ADDENDUM #2 (TWO)

**JOB #2025-02 IMPROVEMENTS TO J. I. BARRON ELEMENTARY SCHOOL
PINEVILLE, LOUISIANA
RAPIDES PARISH SCHOOL BOARD - OWNER**

Yeager, Watson & Associates, LLC; (Job #2025-02/RPSB BID #52-26-01)

10 WALL SECTION AT BUILDING A
SCALE 1" = 1'-0"

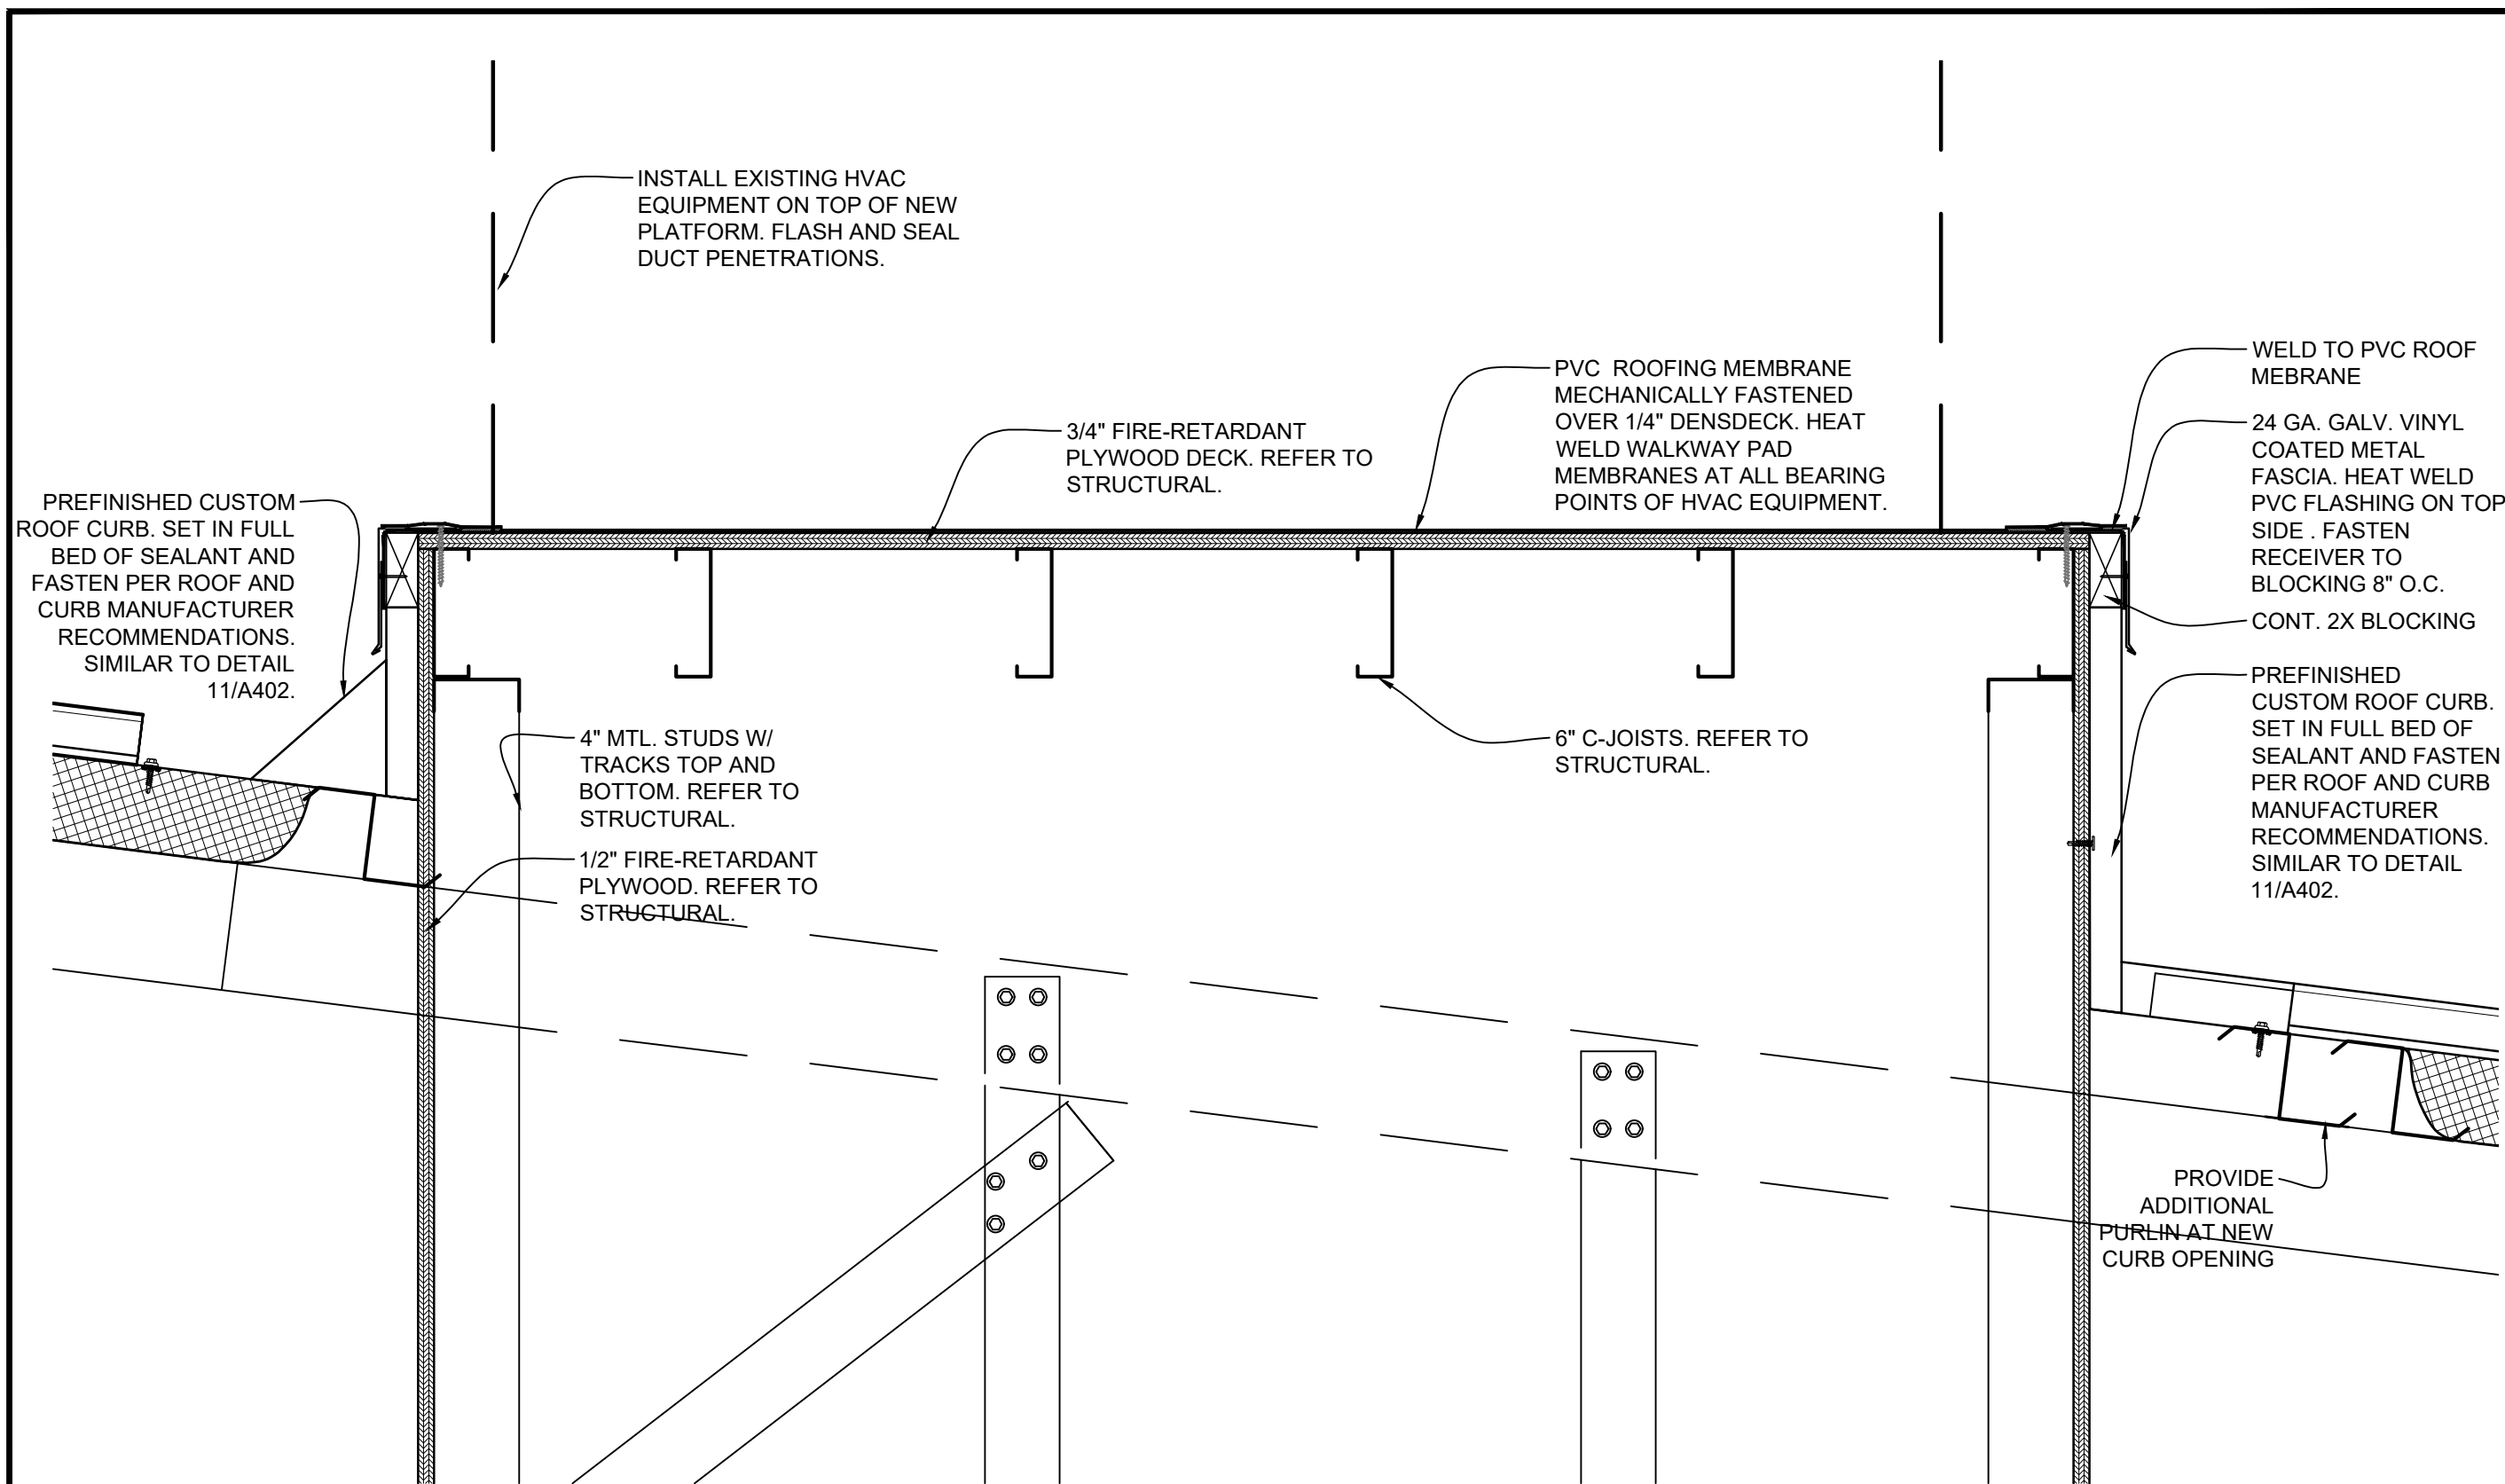
1. **ADD** Detail 10/A401 attached to this addendum.

13 MECHANICAL PLATFORM DETAIL

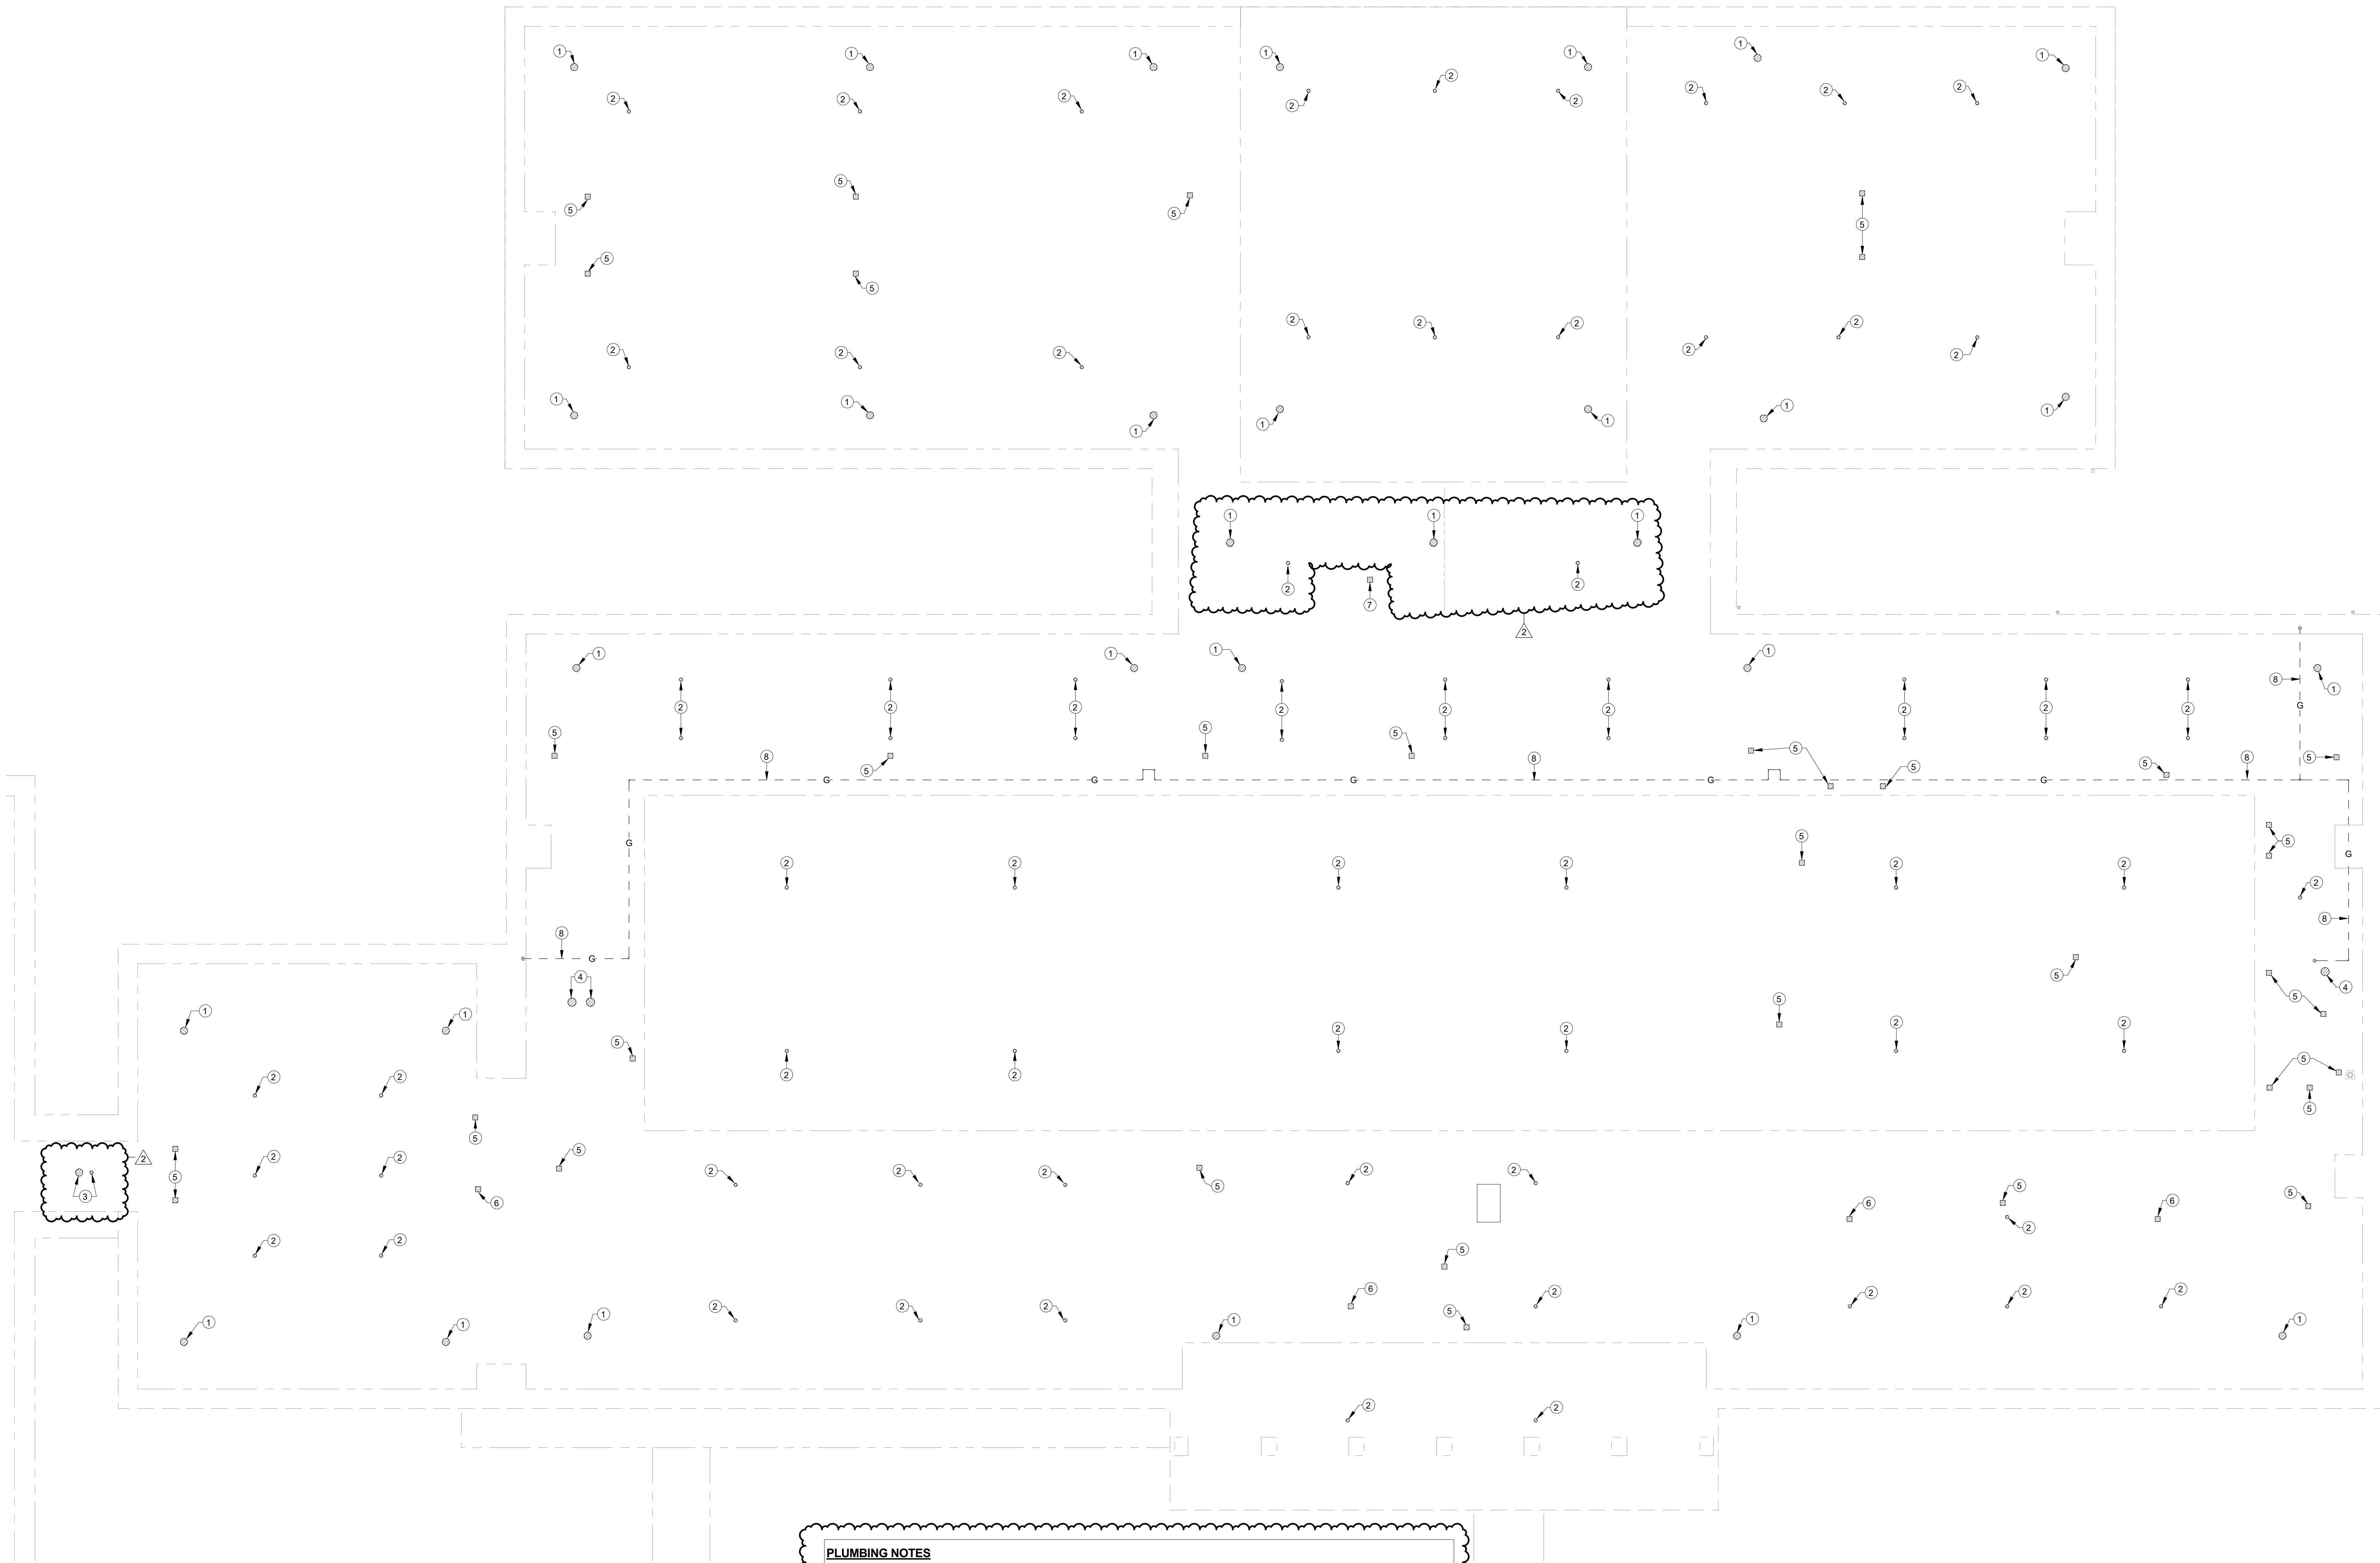
1. **ADD** Detail 13/A402 attached to this addendum.

PLUMBING ROOF PLAN - DEMO

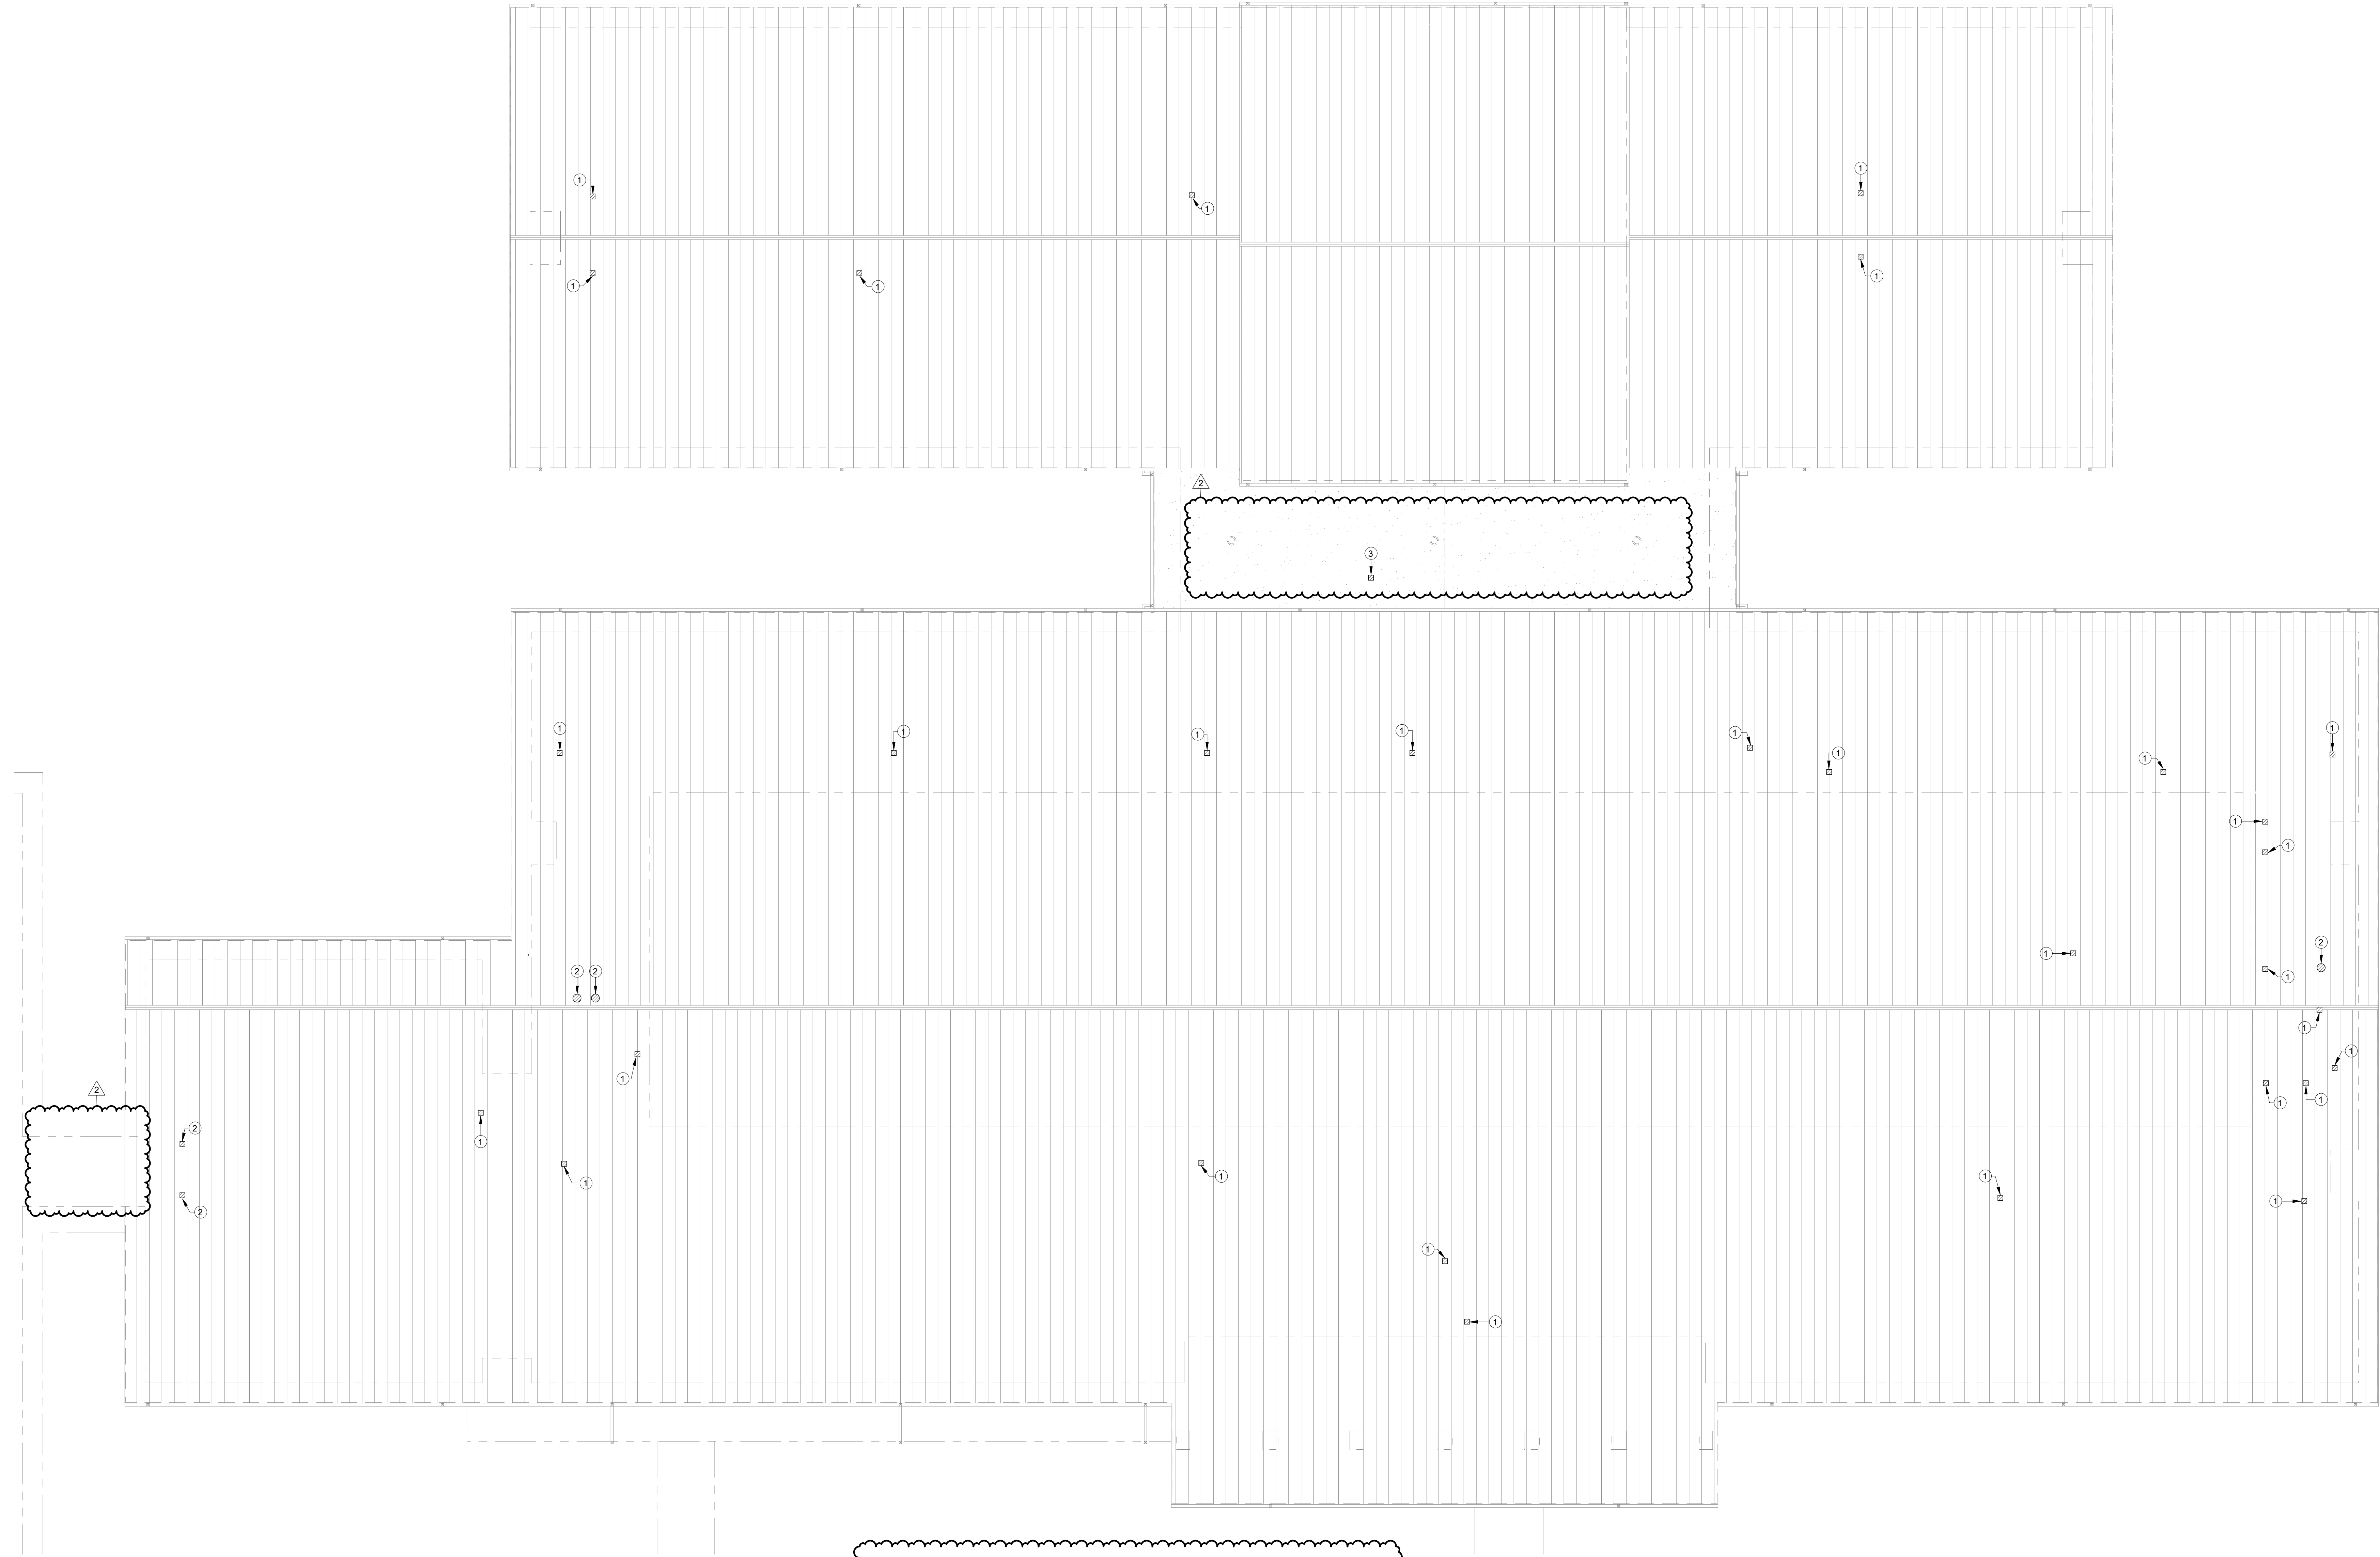
1. **REPLACE** sheet in its entirety with the REVISED sheet attached.
2. Adjusted plumbing notes, refer to clouded areas for adjustments.

- 1 PLUG AND SEAL EXISTING ROOF DRAIN/PIPING.
- 2 PLUG AND SEAL EXISTING OVERFLOW ROOF DRAIN/PIPING.
- 3 EXISTING ROOF DRAIN AND OVERFLOW ROOF DRAIN TO REMAIN.

- 4 REPLACE EXISTING FLUE VENT THROUGH ROOF WITH NEW FLUE VENT. CONTRACTOR TO VERIFY AND MATCH EXISTING SIZE AND MATERIAL IN FIELD PRIOR TO STARTING WORK. CONTRACTOR SHALL EXTEND NEW FLUE VENT HIGHER TO PENETRATE THROUGH NEW ROOF.

- 5 EXISTING SANITARY VENT THROUGH ROOF LOCATED IN THIS VICINITY. EXTEND EXISTING VENT HIGHER TO VENT THROUGH NEW ROOF. VERIFY AND MATCH EXISTING PIPE SIZE AND MATERIAL IN FIELD PRIOR TO STARTING WORK.

- 6 EXISTING CAPPED SANITARY VENT THROUGH ROOF IN THIS VICINITY TO REMAIN.
- 7 EXISTING SANITARY VENT THROUGH ROOF TO REMAIN. PROVIDE NEW FLASHING, ETC. TO BE INSTALLED WHEN NEW ROOFING APPLIED TO EXISTING DECK (AS DIRECTED BY ARCHITECT).

- 8 EXISTING ROOFTOP NATURAL GAS PIPING TO BE REPLACED WITH NEW NATURAL GAS PIPING. CONTRACTOR SHALL VERIFY AND MATCH EXISTING PIPE SIZES IN FIELD PRIOR TO STARTING WORK.
